CITY OF OREGON CITY PLANNING COMMISSION AGENDA

Staff Report

GLUA-21-00045 / MAS-21-00006 / VAR-22-00001 Park Place Crossing General Development Plan

To: Oregon City Planning Commission
From: Planning Division
Re: Park Place Crossing (GLUA-21-00045) supplemental conditions and options for Planning Commission consideration

Condition 23c as written:

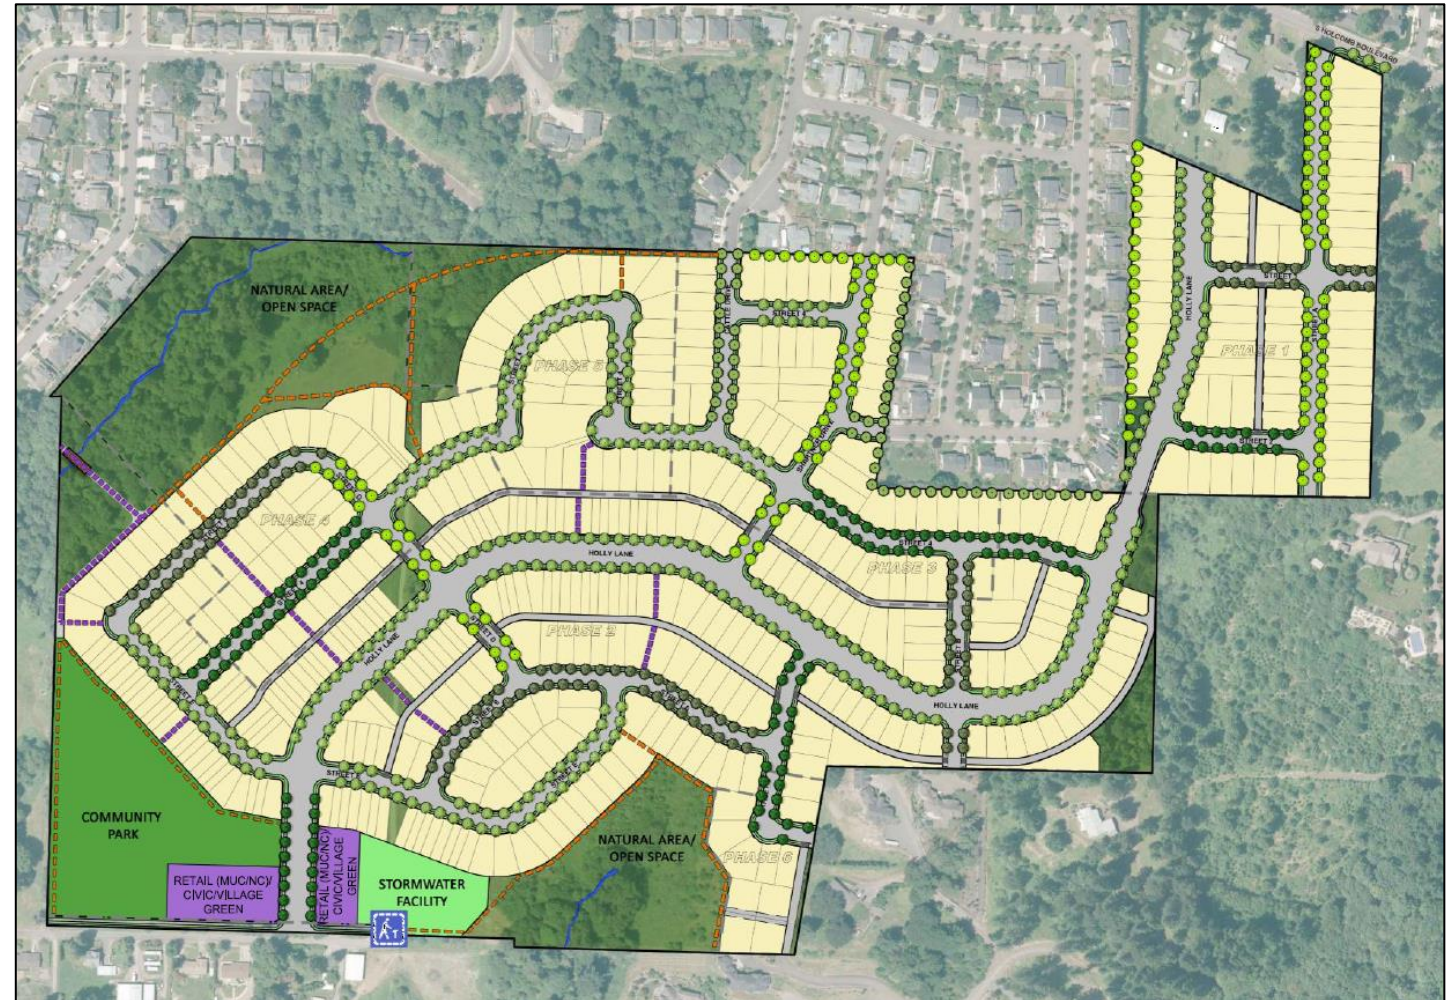
“Provide an additional local street connection to the east of Holly Lane and South of Street E.”

The staff recommendation includes conditions of approval requiring the applicant meet the maximum block lengths and provide an additional local street connection to the east of Holly Lane. The applicant has indicated that topography and proposed stormwater detention pond location make a street connection highly challenging in this location.

It is likely that the inclusion of a local street connection in this area would result in major revisions to the layout of the development. There may be tradeoffs associated with providing the street connection, and the level of discretion to assess the tradeoffs is high. Therefore, staff recommends that the Planning Commission be the arbiter of this issue via the Type III Master Plan refinement.

Impact of missing streams

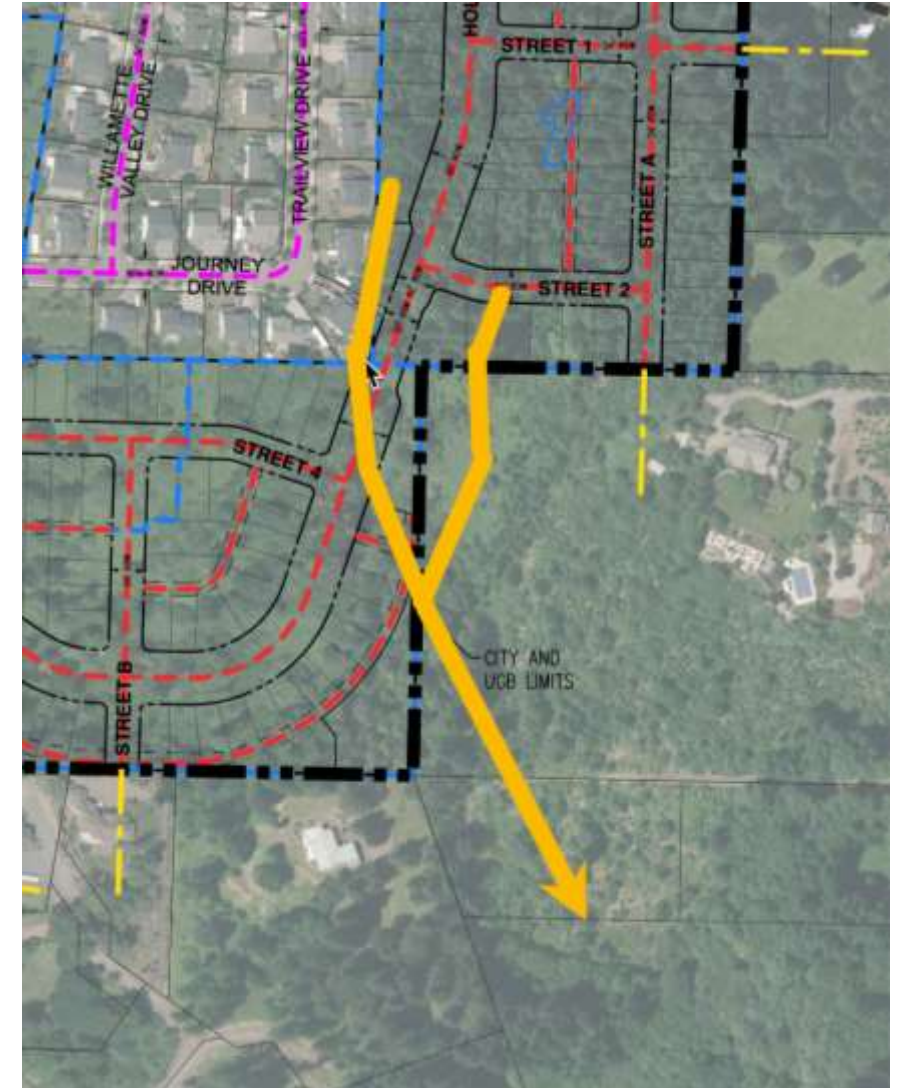
- Potentially affects
 - Holly Lane
 - Street 2
 - Lots 26-28
 - Lots 60-62
 - Lot 314
- Regulated by OCMC
 - 17.49.070
 - 17.49.080
 - 17.49.090
 - 17.49.100
 - 17.49.110

Figure 1. Oregon City Local Wetland Inventory

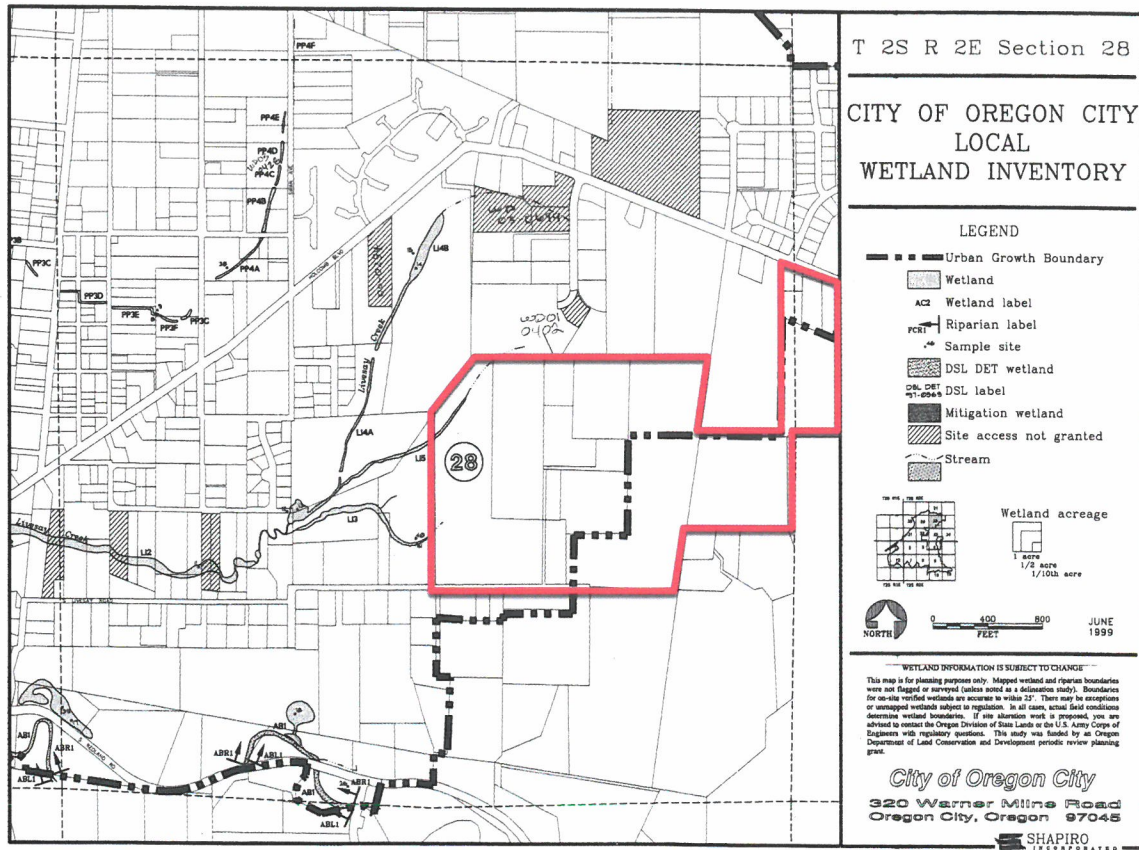
Unfortunately, the 1999 OC LWI [Figure 1] is out of date and does not include all of the subject property (outlined) in the PPC GDP. Furthermore, the official OC NROD Boundary Map [Figure 2] similarly excludes part of the subject property (outlined). Note that the vegetative corridor markings terminate abruptly at the urban growth boundary (UGB), even though the streams and waterways obviously extend past the UGB.

Figure 3. NROD Existing Conditions Map, Exhibit 6

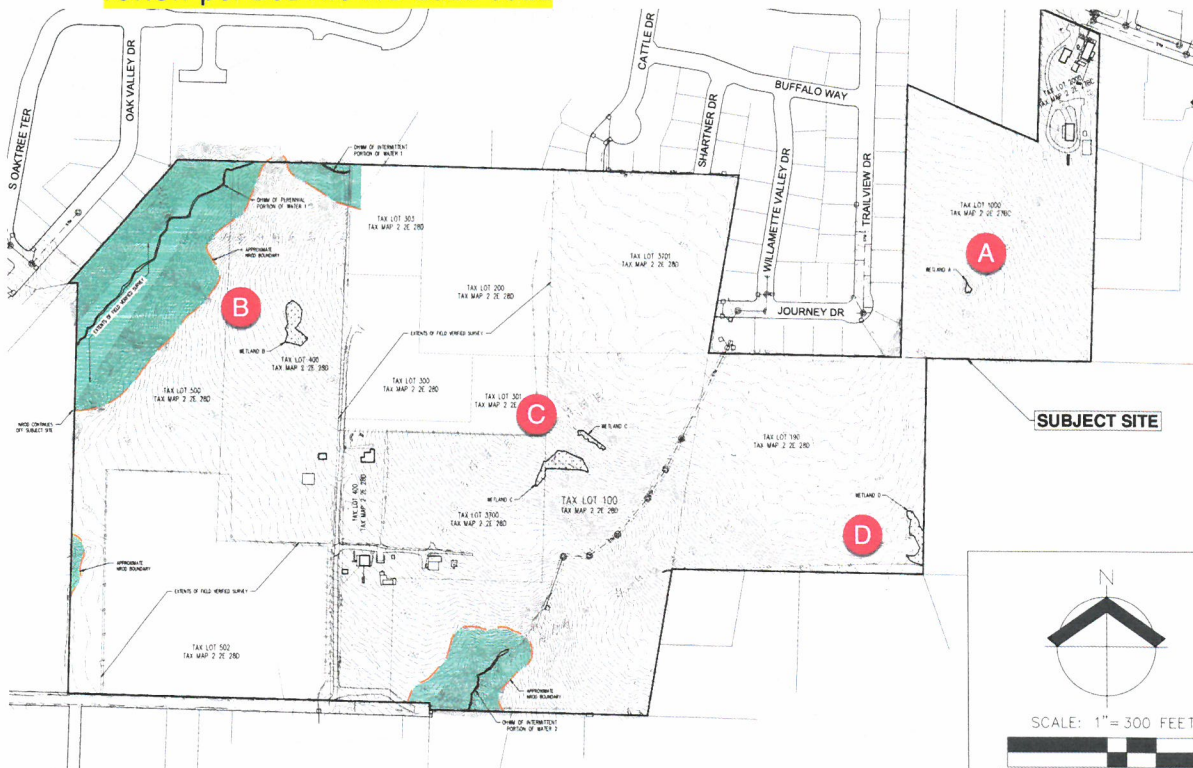
- A wetland and waters delineation report in accordance with OAR 141-090-0030 and OAR-141-090-0035 (1-17) was prepared by AKS to describe the results of a wetland and waters delineation. **The delineation report was submitted to DSL and is currently under review per DSL File WD 2021-0311.**

Figure 4. AKS provided NROD Boundary Map

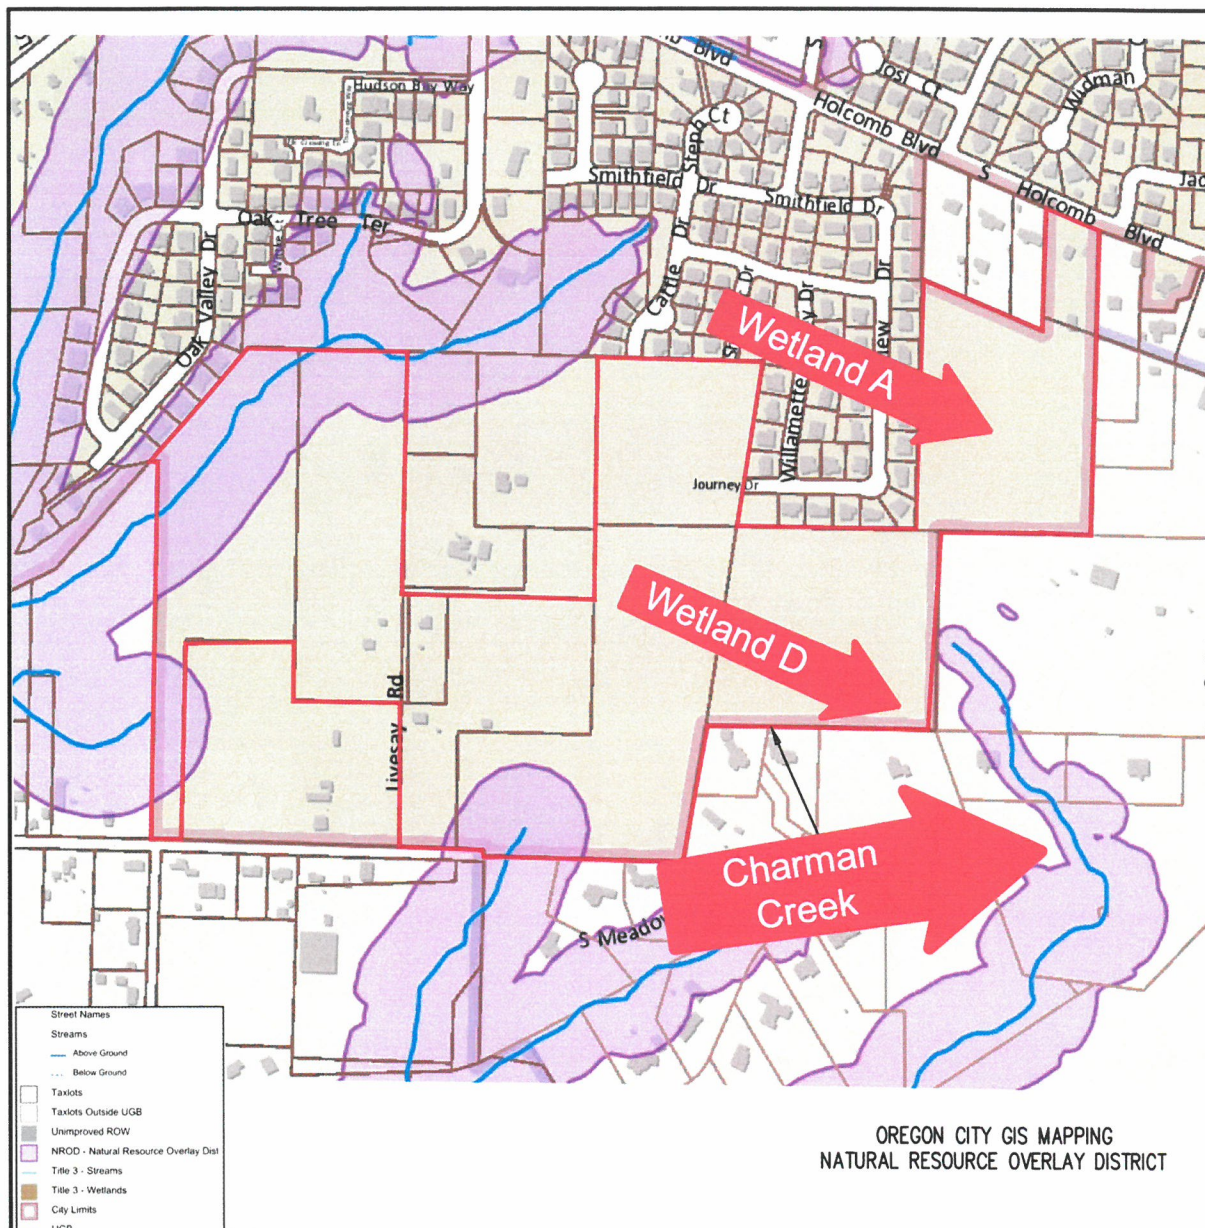
The AKS NROD Analysis also includes a topographical map of the Oregon City Quadrangle [Figure 5]. It clearly shows the presence of Charman Creek – a tributary feeding into Holcomb Creek. The most upland portion of Charman Creek extends onto Tax Lots 1000 and 109, which represent Phase 1 and Phase 2 of the PPC GDP. These waterways are absent on the AKS NROD Boundary Map [Figure 6].

Figure 9: Reduced S Holly Lane Cross-Section

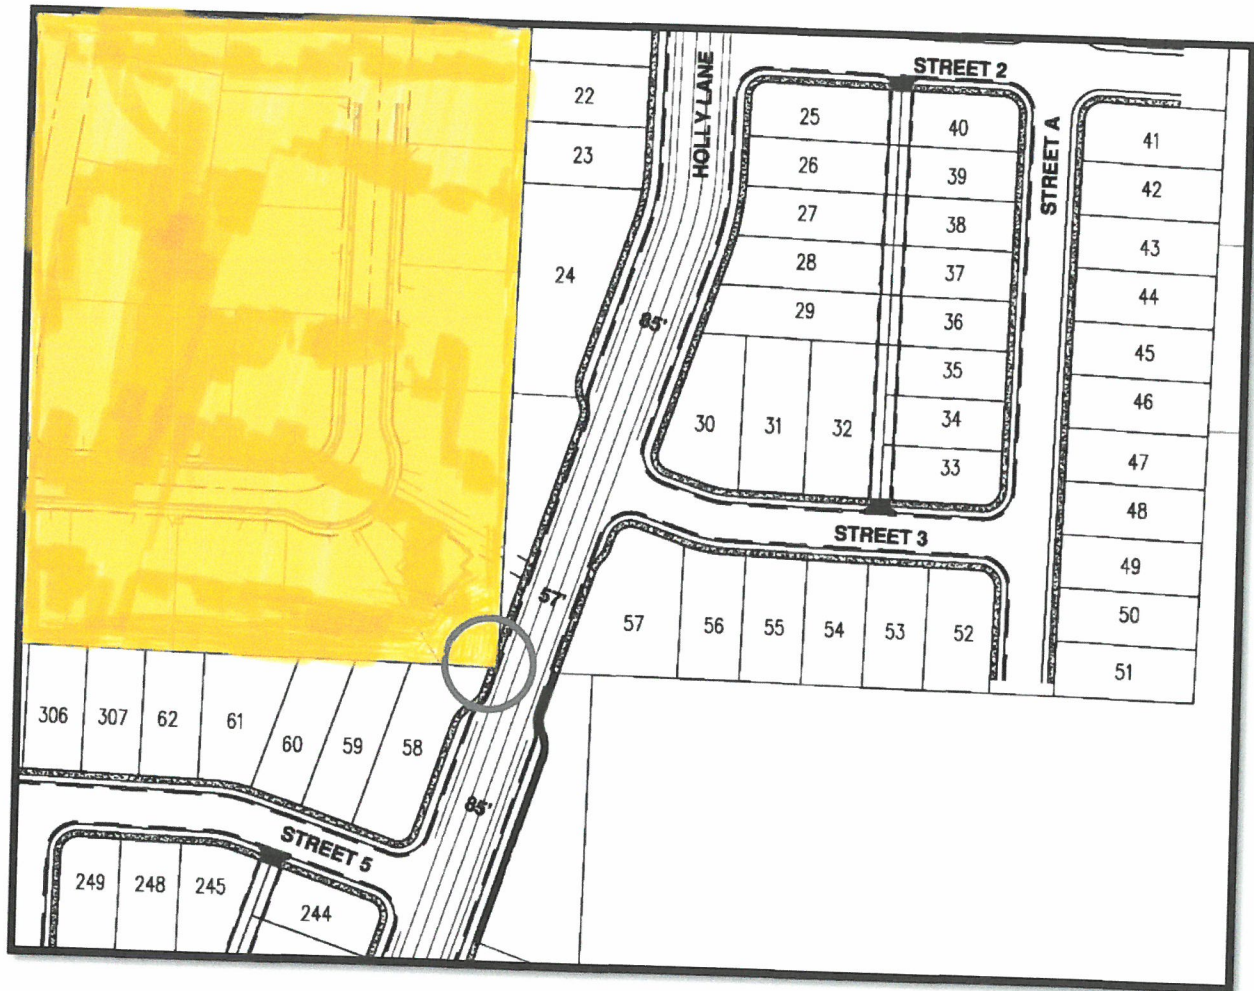
The area in yellow is governed by the Covenants, Conditions, and Restrictions for Trailview Heights Subdivision recorded January 16, 2003 as Document No. 2003-006569 in the records of Clackamas County. When Icon purchased Lot 14 in 2020, they agreed to abide by these CC&R's. These will not allow Lot 14 of Trailview to be used for any construction related to Park Place Crossing, including the new sidewalk that crosses Lot 14 on Icon's drawings. Nor will we approve any alterations or allow variances to the property itself.
